# **Centennial Mandalong Pty Ltd**

## **Mandalong Mine LW30-31 Extraction Plan WMP**

**Mandalong Southern Extension Project (SSD-5144)  
Extraction Plan – Longwalls 30 - 31  
Request for Information**

**Attachment A**  
**Mandalong Southern Extension Project SSD5144**  
**Extraction Plan Longwalls 30-31**  
**Review Comments – 07 June 2021**

DRAWN	F.M				
	CHECKED	I.G				
	APPROVED	S.G.				
	SCALE	refer to scalebar	<div>DATE 11/06/2021</div>		<div>Figure 2-2</div>

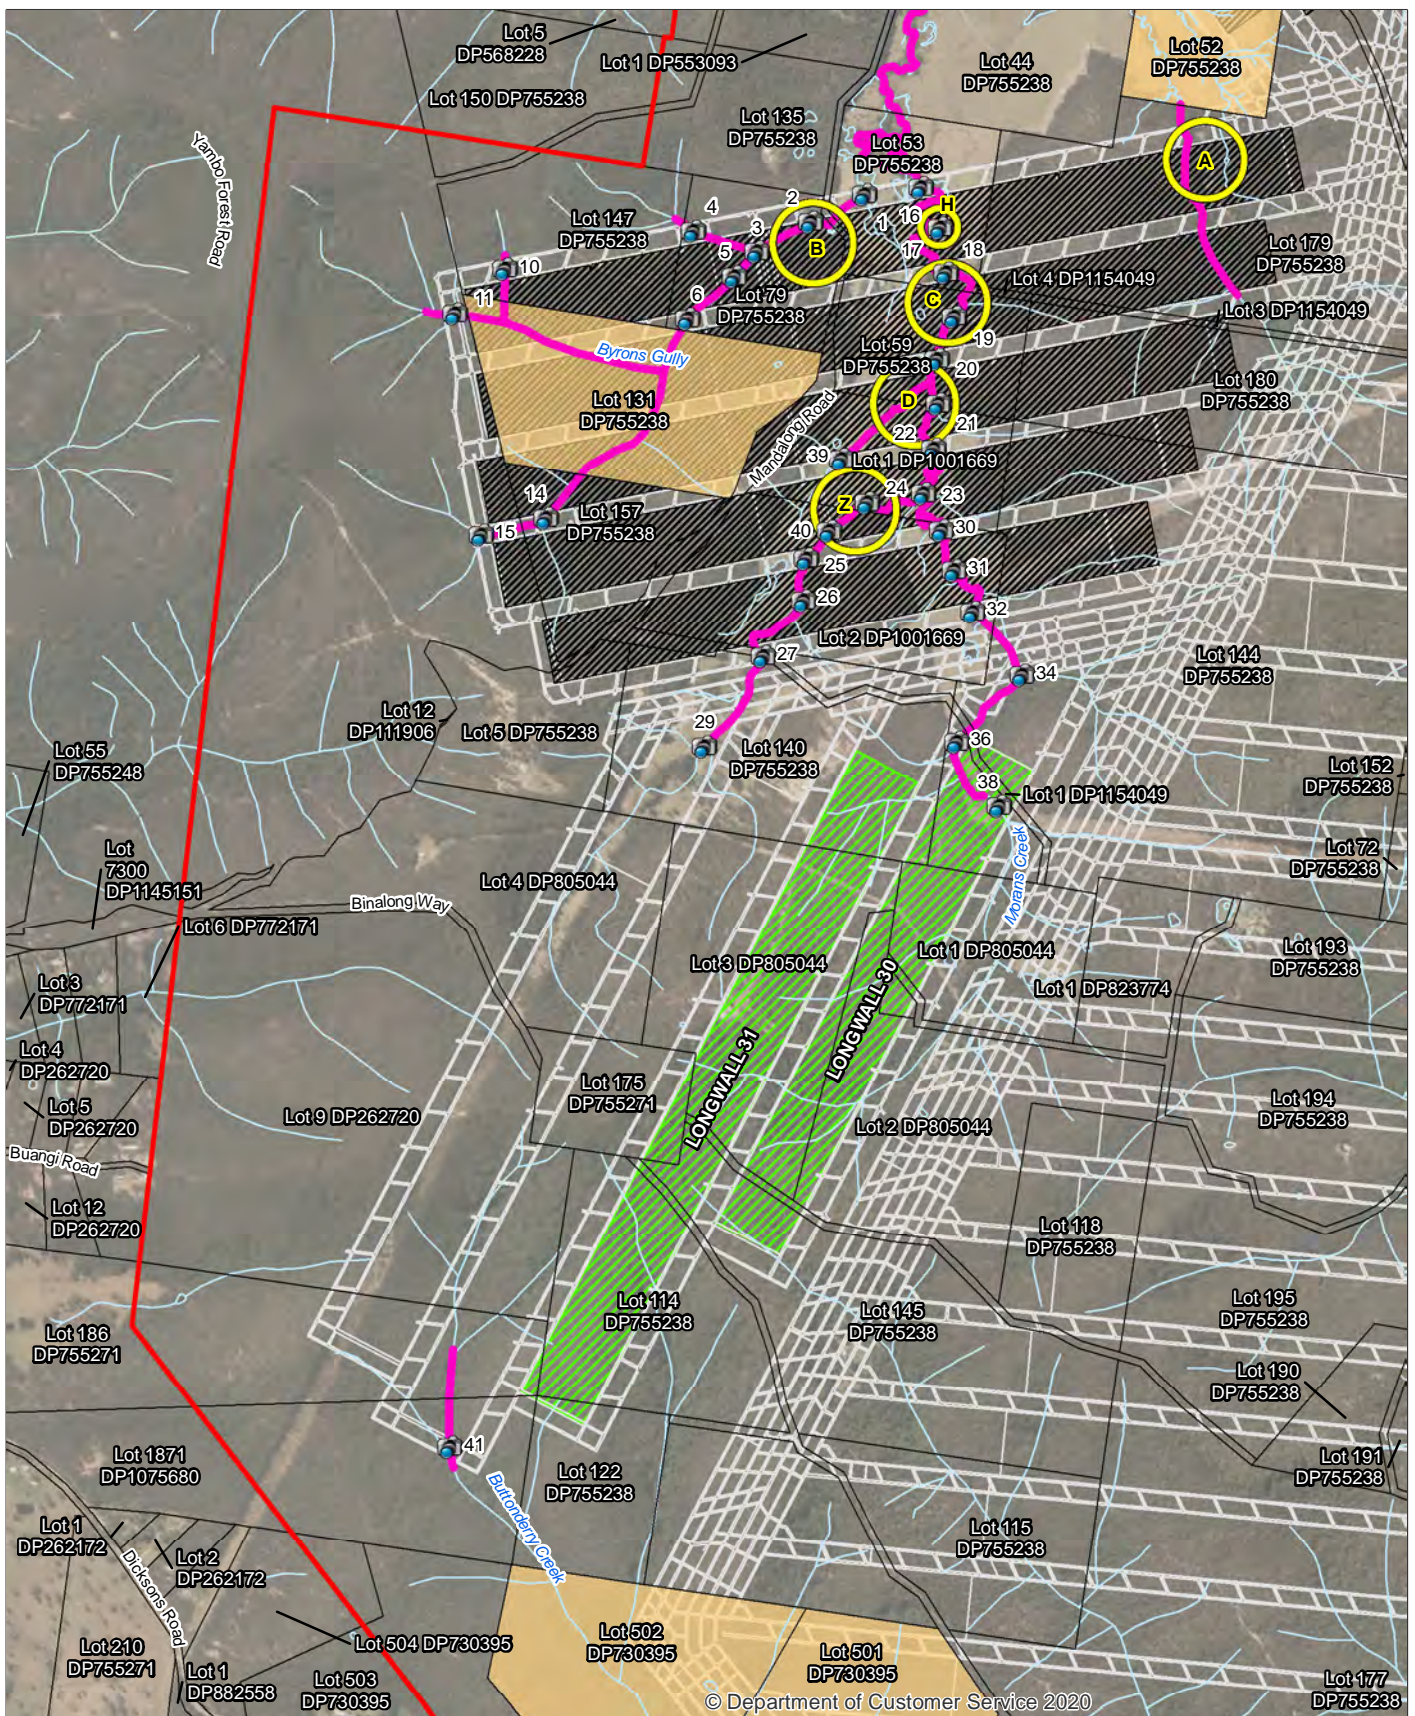
<b>Extraction Plan: Condition 6, Schedule 4</b>	<b>Satisfactory (Yes/No)</b>	<b>Comment</b>	<b>Action Required</b>
<ul style="list-style-type: none"> <li>a program to monitor and report on stream morphology and stream flows, and assessment of any changes resulting from subsidence impacts, including scouring and ponding;</li> </ul>	Partial	<ul style="list-style-type: none"> <li>Section 4.3.2 – Table 4-8 has been updated to reflect contemporary commitments to watercourse subsidence impacts following Mod 9.</li> <li>Section 2.1.3 describes the monitoring of stream, flow path and ponding. Figure 2-2 shows the monitoring locations. However these do not reflect the additional two ponding locations identified following approval of Mod 9.</li> <li>Section 4.3 – details performance criteria for watercourses, stream health (including geomorphic condition and waterway stability).</li> </ul>	<ul style="list-style-type: none"> <li>Please update Section 2.1.3 and Figure 2-2 to reflect the two predicted additional ponding locations occurring above LW30 as identified in MOD 9.</li> <li>Figure 2-2 - Please review and align monitoring points with Table 2-2. ie. is location C or G?</li> </ul>

Figure 2-2 - Please review and align monitoring points with Table 2-2. ie. location C or G	Monitoring points have been reviewed and updated to ensure consistency.

**Figure 1. A demonstrated mining effect on an alluvial bore (BH24A over LW15)**

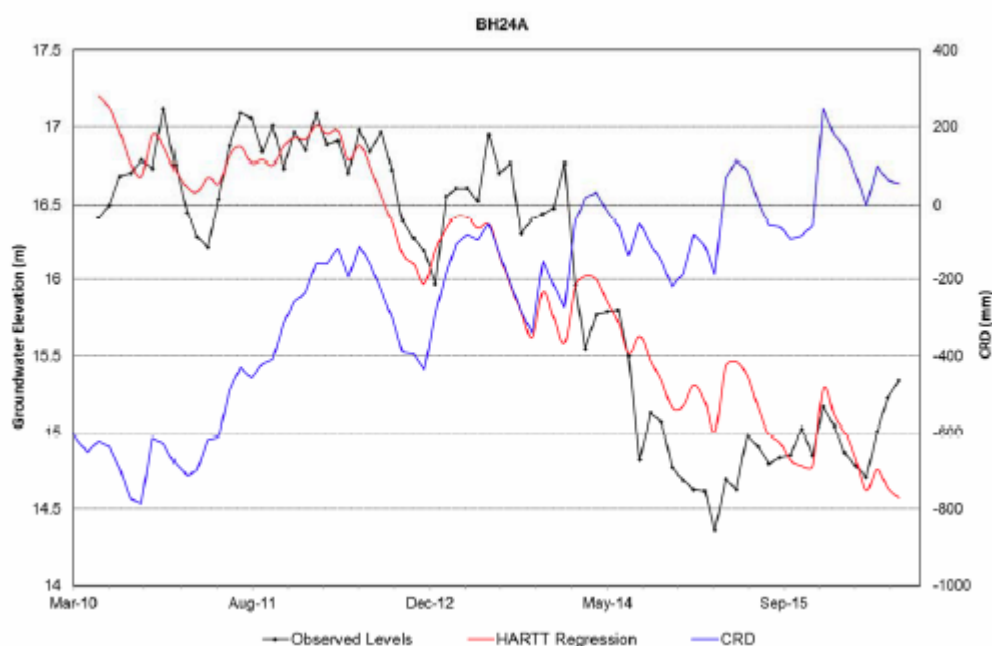
One criticism is that the hydrographic plots (such as Figure 1) should show “mAHD” as the groundwater elevation unit (not “m”). Often, for shallow bores with rapid response time, a better correlation would be found with rainfall residuals rather than cumulative residuals (CRD).

**Figure 5. Comparison of the 2014 base case model predicted mine inflow with current Run 24 model [the actual mine inflow at January 2016 was about 0.8 ML/day]**

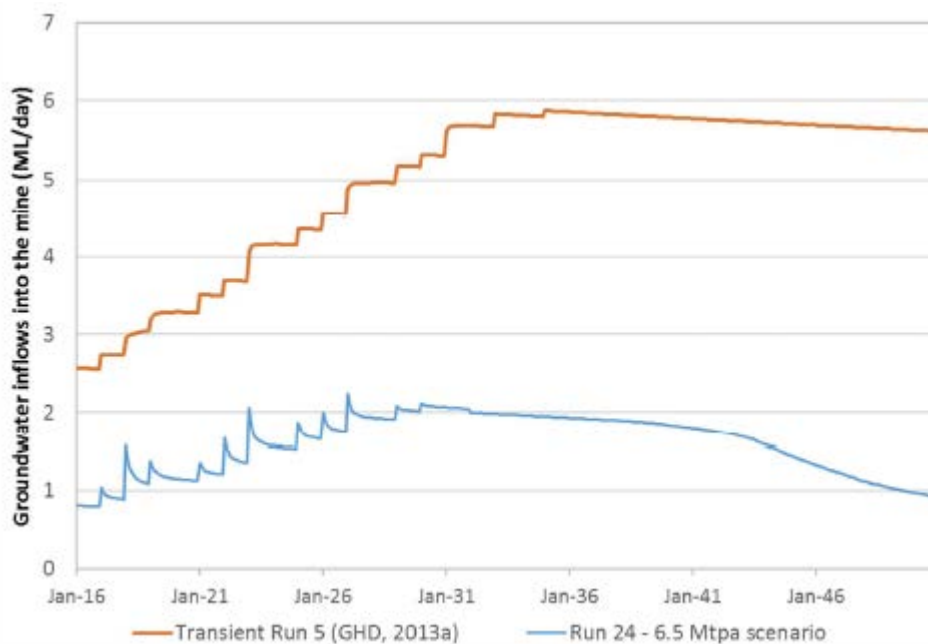
It is clear from **Figure 5** that the predicted mine inflow is now much lower than previously reported. It follows that any environmental impacts or drawdown effects at private bores would now be much less. The new model predicts no more than 10 cm drawdown on the water table in alluvium or outcropping Triassic sandstone. In the Permian overburden, however, the 2 m drawdown extent is predicted to be wider due to the incorporation of lower storage properties in the model. Section 6.4.1 in Document #1 examines the potential impact on 31 registered private bores (Table 6-6) and concludes that only four bores lie within the 2 m drawdown extent and, due to their elevations or operational status, none is likely to be affected by more than 2 m drawdown.
